**E6198A-04****S E R V I C E N O T E**Supersedes:  
NONE

E6198A Switch Load Unit (SLU)  
- used in E8780B, E8781A, E8786B, and E2240A

Enhancement solution is available to SLU backplane discoloration issue by  
removing the preload resistors from backplane.

Figure 1. Discoloration mark on the SLU backplane near the area of preload resistors.

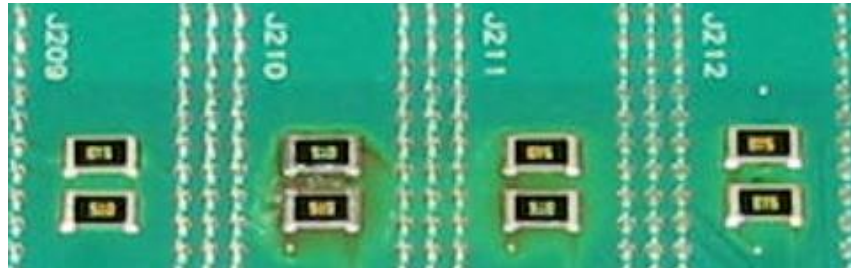
Agilent has recently received some feedbacks regarding the discoloration marks seen on the SLU backplane (E6170-66502) near the area of preload resistors (see Figure 1). As proactive response to the feedbacks, we have done the root cause analysis and safety evaluation on the backplane. The result shows that this discoloration mark was due to heating from the resistors and it will NOT cause any safety concerns.

Despite the SLU backplane is still safe to be used, Agilent would like to offer an enhancement solution to the matter by removing the preload resistors from the backplane. The removal will bring the following benefits to the users (1) prevent the discoloration from further deteriorating, (2) extend the life span of the backplane, and (3) increase the current consumption bandwidth of internal power supply.

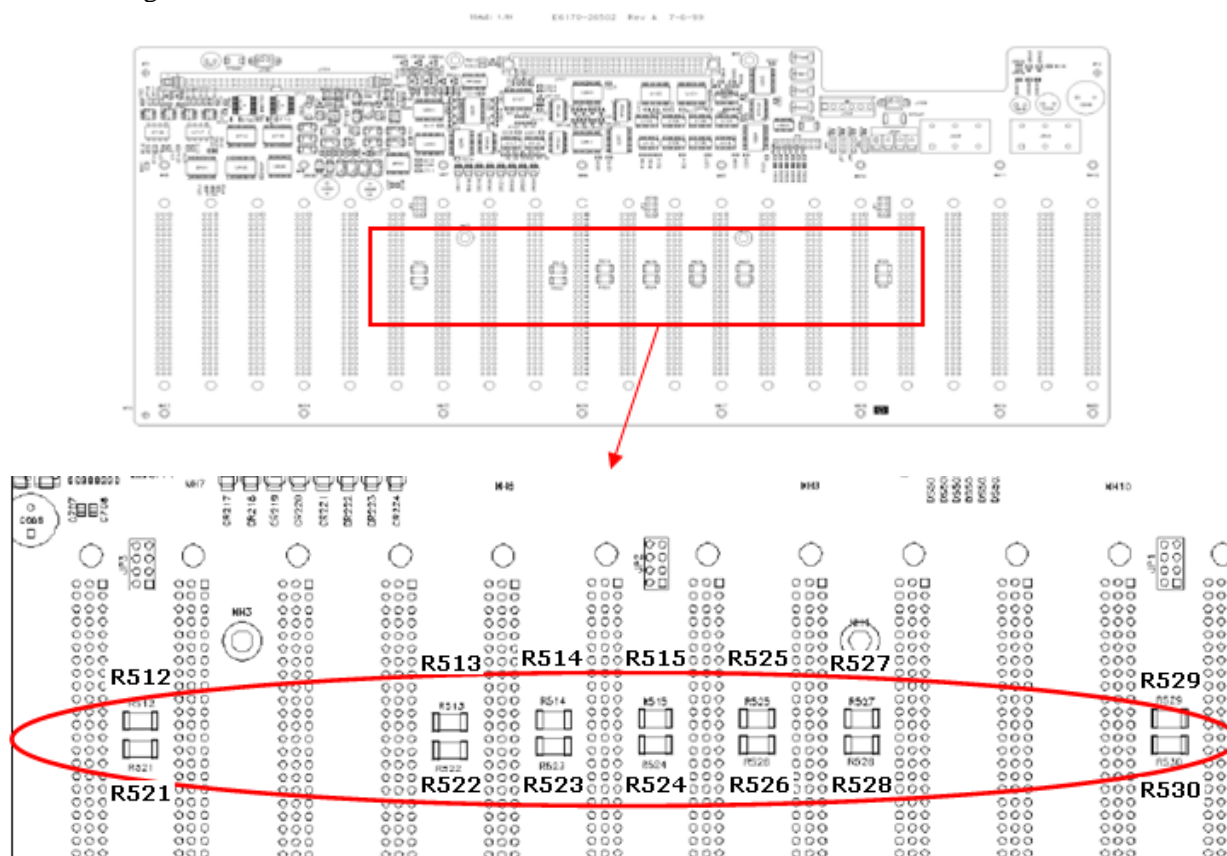
9. Remove the 14 preload resistors (circled in red) from the backplane using Agilent recommended Chip Component Removal method stated in the IPC-7711A/7721A (or equivalent). Make sure the de-soldering work is clean to avoid short circuits.
